1968 Corvette: Service Bulletin: Gas Line Rattle

Bulletin No: 68-IC-54

Date: June 29, 1968

Fig. 1.

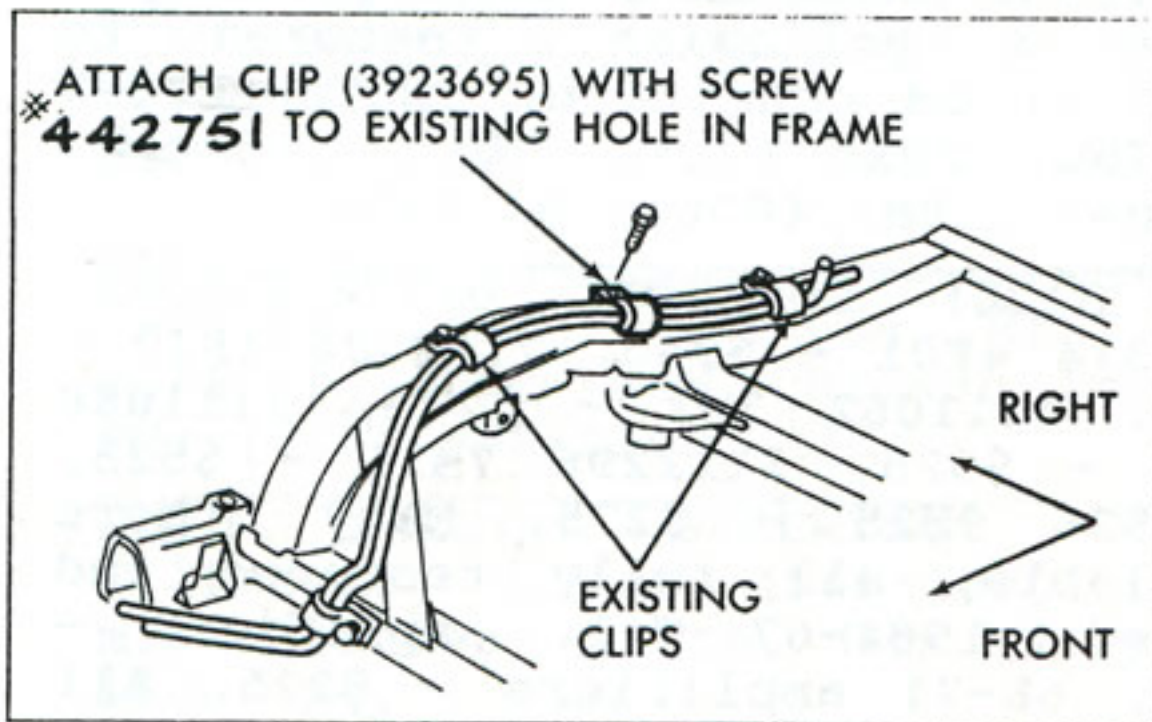
A rattling or "ticking" noise from the rear of the vehicle has been experienced on some 1968 Corvettes. This noise is resulting from the fuel supply line vibrating against the return line. Production has corrected this condition by installing an additional clip in the existing frame hole at this location. Refer to Fig. 1. This same correction is recommended for units in the Field that are experiencing the rattling or "ticking" noise. Fig. 1 illustrates where the clip should be added and gives the related parts data.
